MBARI
COMMENTS ON FINAL DESIGN SPEC. (DRAFT) Rev 0.0
TIBURON II ROV SYSTEM

Document: EJ47 Comments on draft tech spec rev0.0

The following comments are based on the MBARI document entitled 'MBARI's Tiburon II Final Design Specification (DRAFT) Revision 0.0'. The item and title in the table of section 2 of this document reflects the sections of the MBARI specification and the table should therefore be read in conjunction with the MBARI specification.

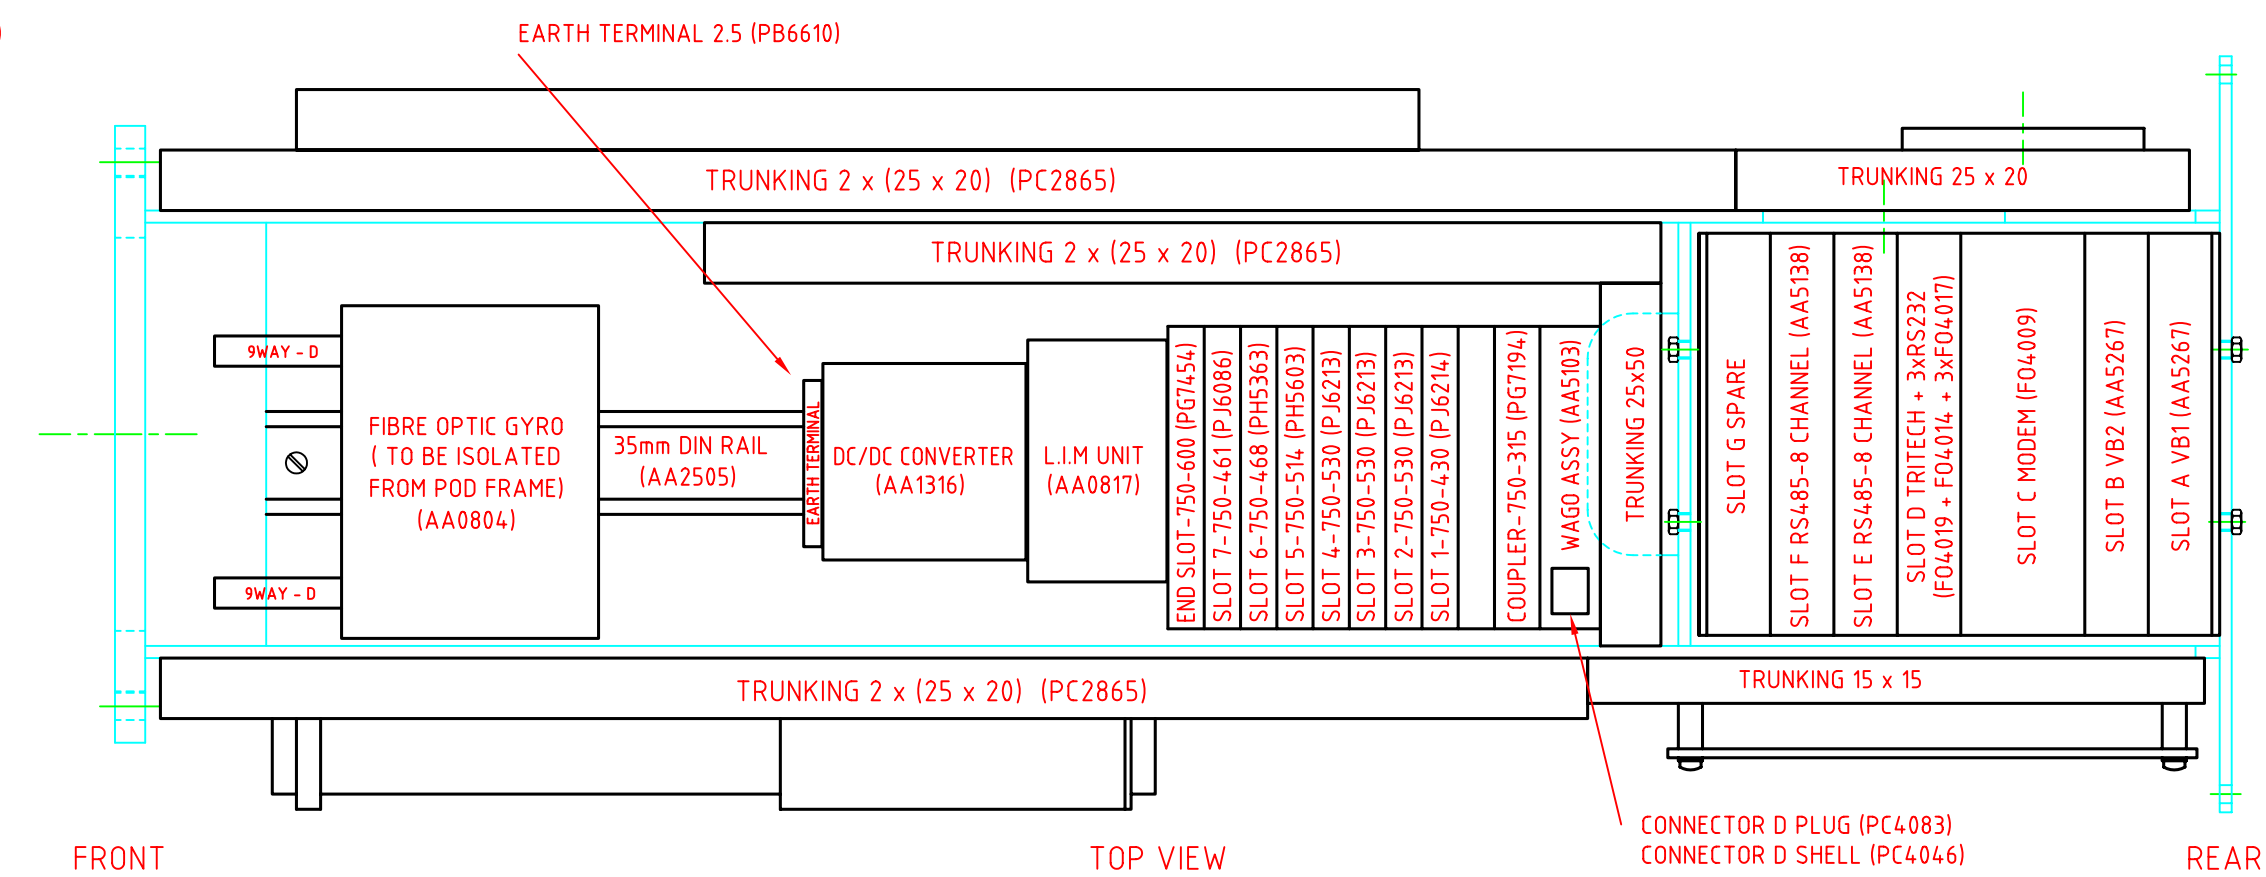
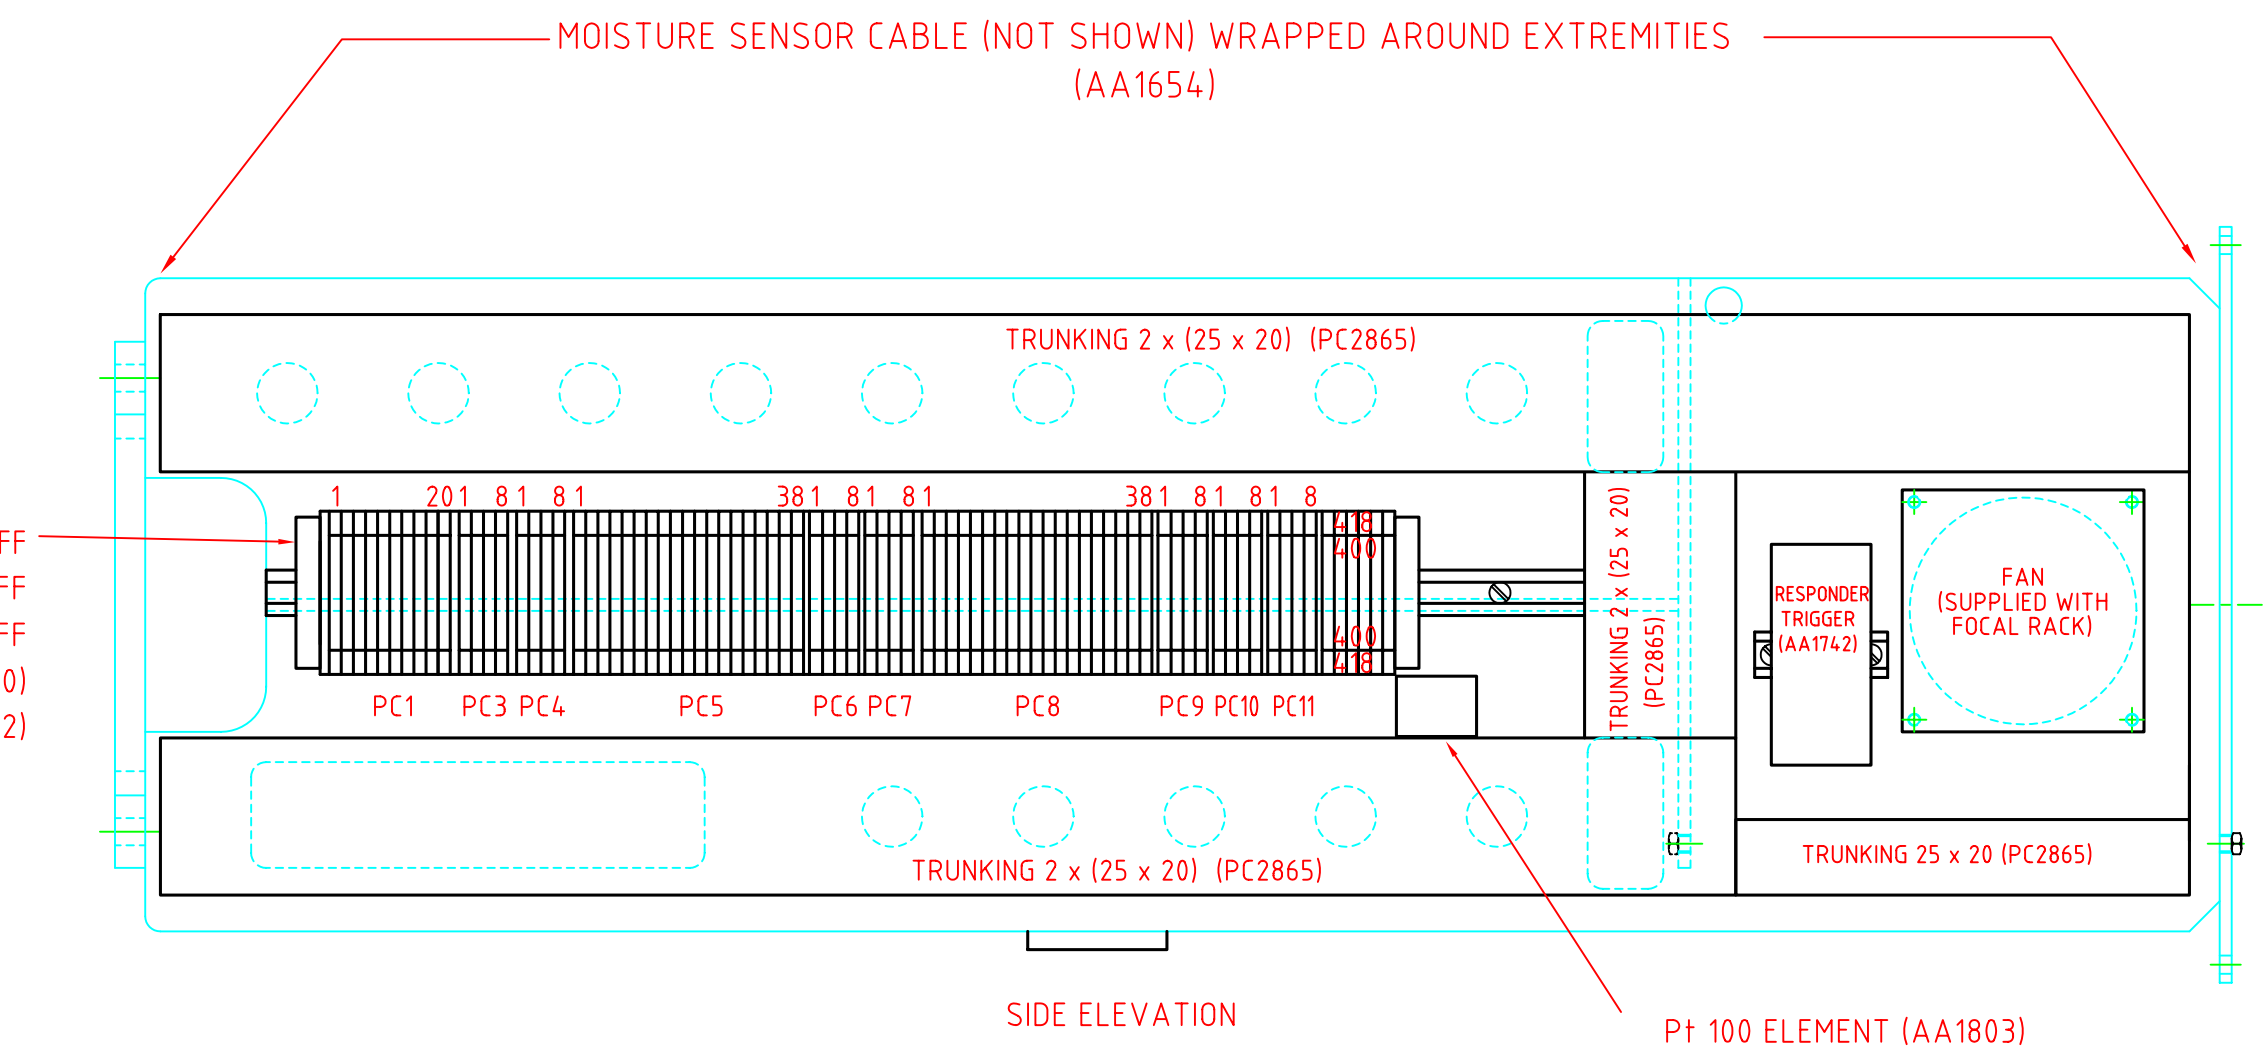
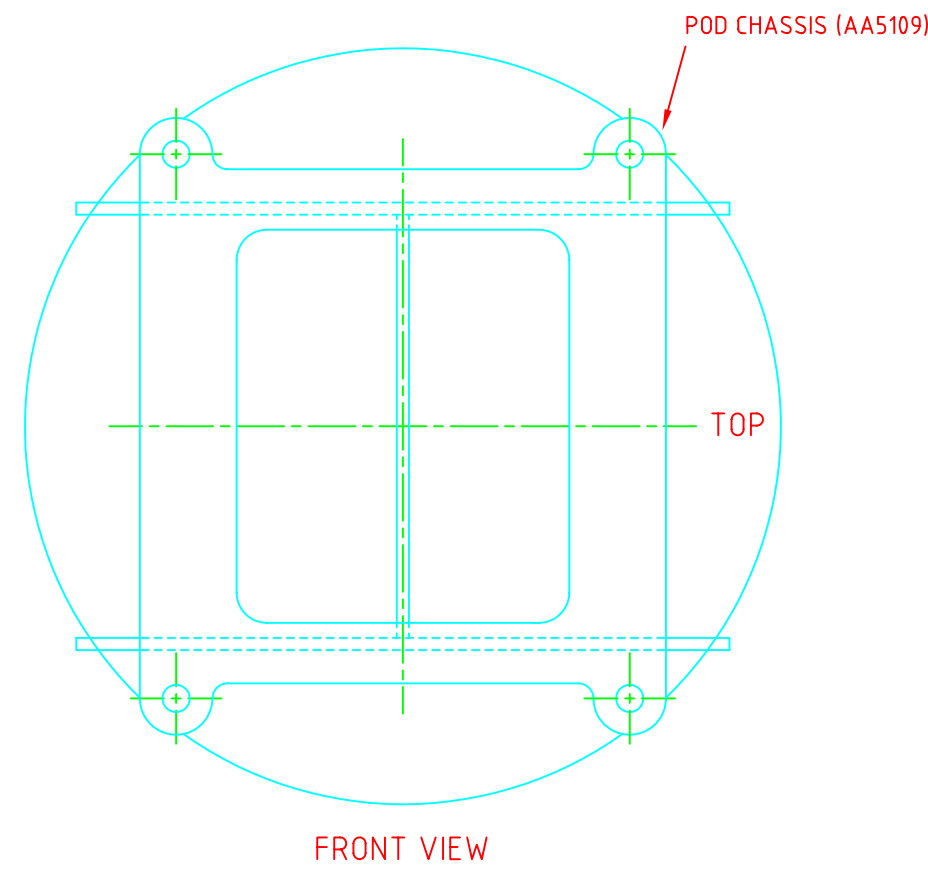
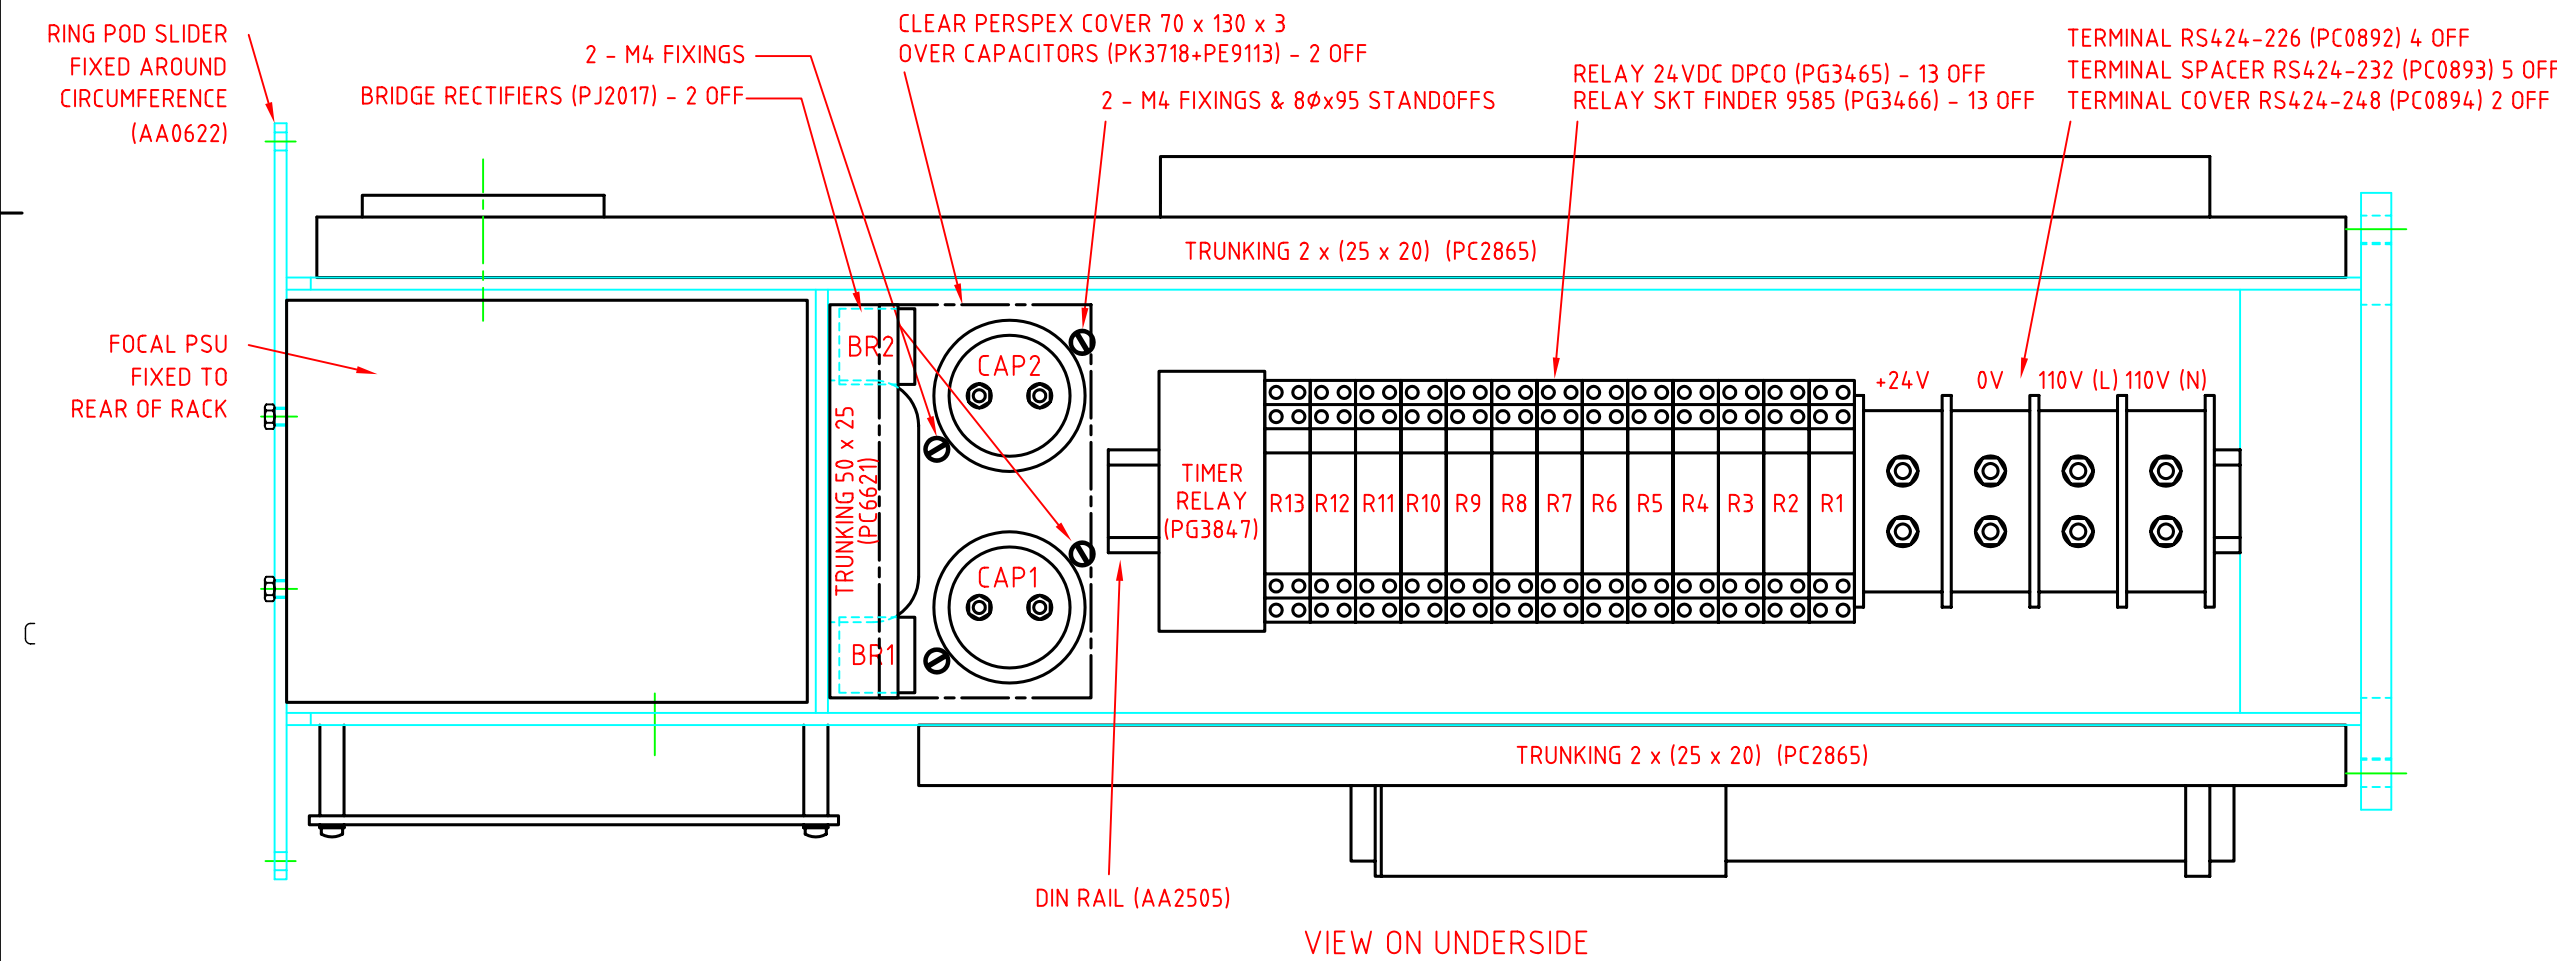
2.2.2	Sub-Sea Control Pod	A general arrangement drawing of the inner chassis of a Quantum electronic pod is provided as an example.
2.2.2.1	Connectors & cables	Agreed
